Report to the Plan Commission

Legistar I.D. #14032
3901 Hanson Road
Certified Survey Map Referral

Requested Action: Consideration of a three-lot Certified Survey Map (CSM) of 37.9 acres of property owned by McAllen Properties Madison, LLC and located at 3901 Hanson Road

PARKS DIV.
EXHIBIT

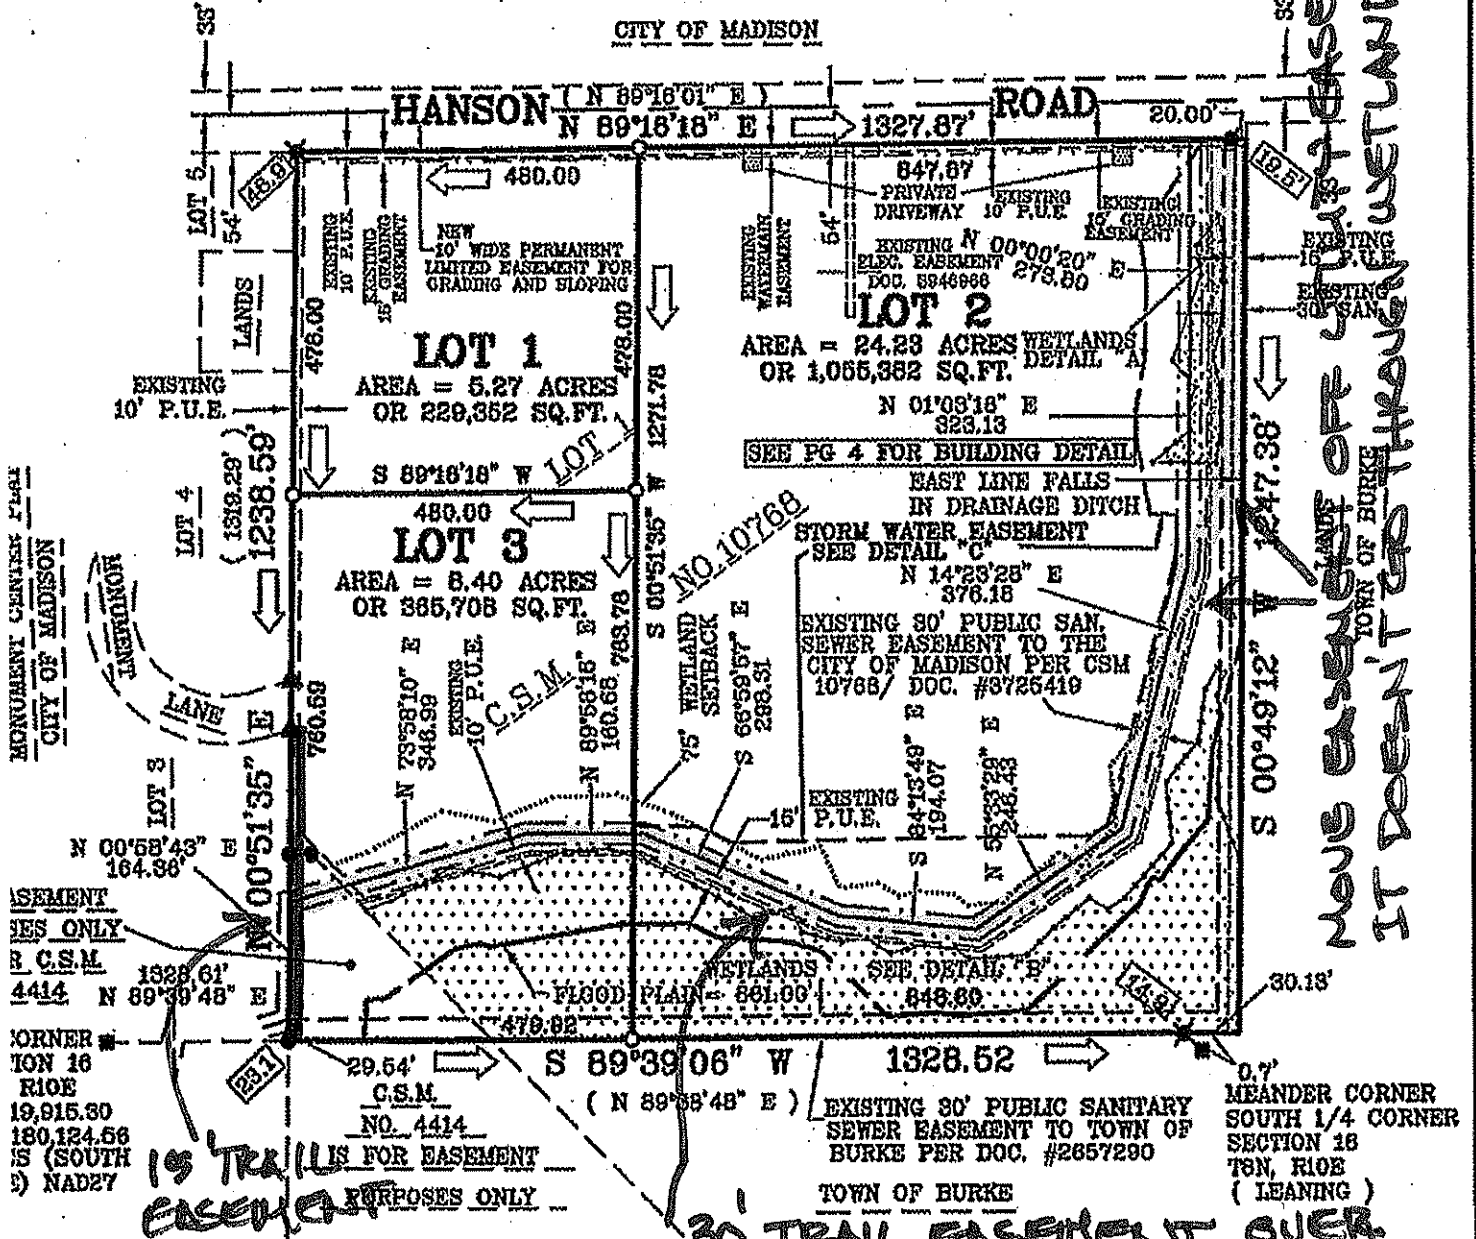
23. The developer will be required to provide a 15-foot wide bike trail easement starting at the southwest corner of the parcel and heading north to Monument Lane, which will result in a total of 30' of easement considering the parcel to the west that already has a 15-foot easement along the west property line.
24. The developer will be required to provide 30-foot bike trail easement over the existing city sanitary sewer and/or other sewer easement that runs adjacent to the wetlands along the south and east property line, heading north to Hanson Road. The bike trail easement should not be on platted wetlands.
25. The developer shall install the gravel base for the bike trail, centering it on the easement along the southern and eastern property lines. The gravel base is to be 12 feet wide and 9 inches deep.

CERTIFIED SURVEY MAP

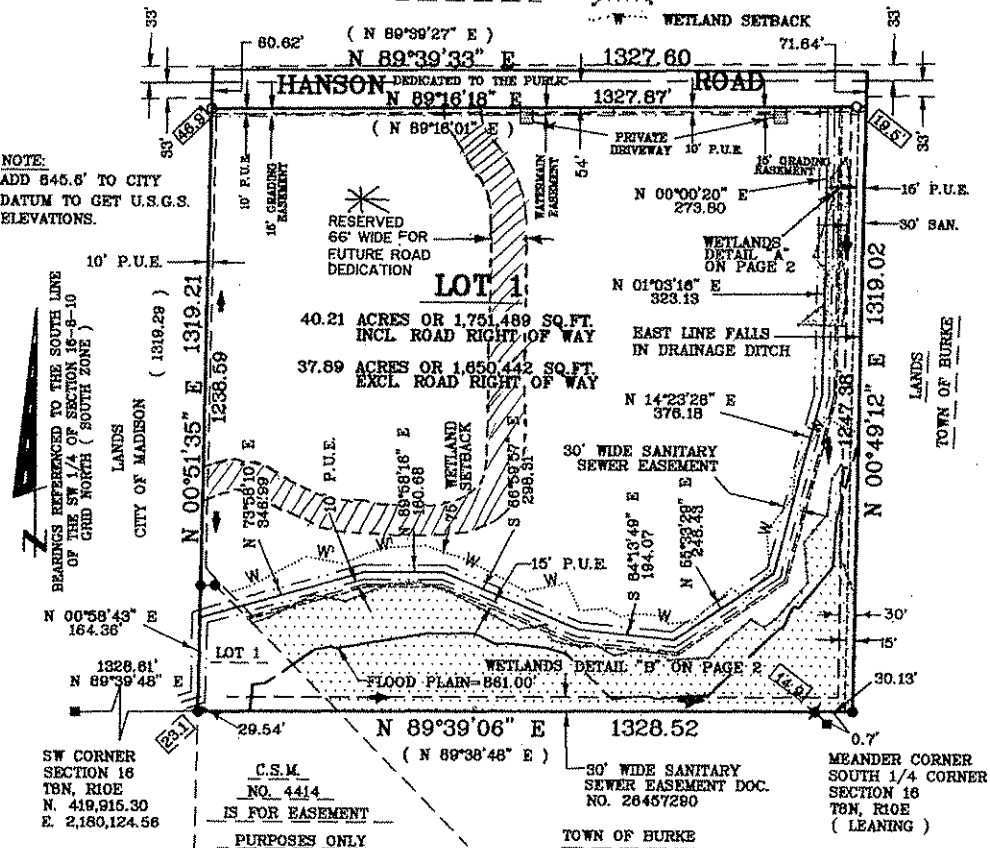
6. Identify the existing 15-foot wide public water main easement similar to how the existing public sanitary sewer easement references the CSM 10768 as Document No. 3725419 that created both easements.

7. CSM 10768 created a 15 feet wide grading easement along Hanson Road. Further clarify this easement as an existing 15-foot public grading and sloping easement. Delete reference to the "NEW" 10-foot wide permanent limited easement along the south right of way line of Hanson Road.

8. The applicant shall dedicate right of way for a cul-de-sac at the end of Monument Lane with a minimum diameter of 120-feet and reverse curves with a minimum radius of 50 feet (100 feet if bulb is offset).

9. Lot 1 of the proposed CSM is not being provided sanitary sewer service under the current lot configuration. The applicant shall dedicate a 20-foot wide public sanitary sewer easement on Lot 3 or Lot 2 prior to serve Lot 1.

17. In accordance with Section s.236.34(1) (c) which says a CSM shall be prepared in accordance with s.236.20(2) (c) & (f), Wisconsin Statutes, the Applicant must show type, location and width of any and all easements. Clearly identify the difference between existing easements (cite Register of Deeds recording data) and easements that are being conveyed by the CSM. Identify the owner and/or benefiting interest of all easements.
18. Prior to Engineering final sign-off by main office for Certified Survey Maps (CSM), final CSM must be submitted to Engineering Division Surveyor / Land Records Coordinator for final technical review and approval. This submittal must occur a minimum of two working days prior to final Engineering Division sign-off. Electronic mail submittal of the FINAL CSM in PDF form is preferred.
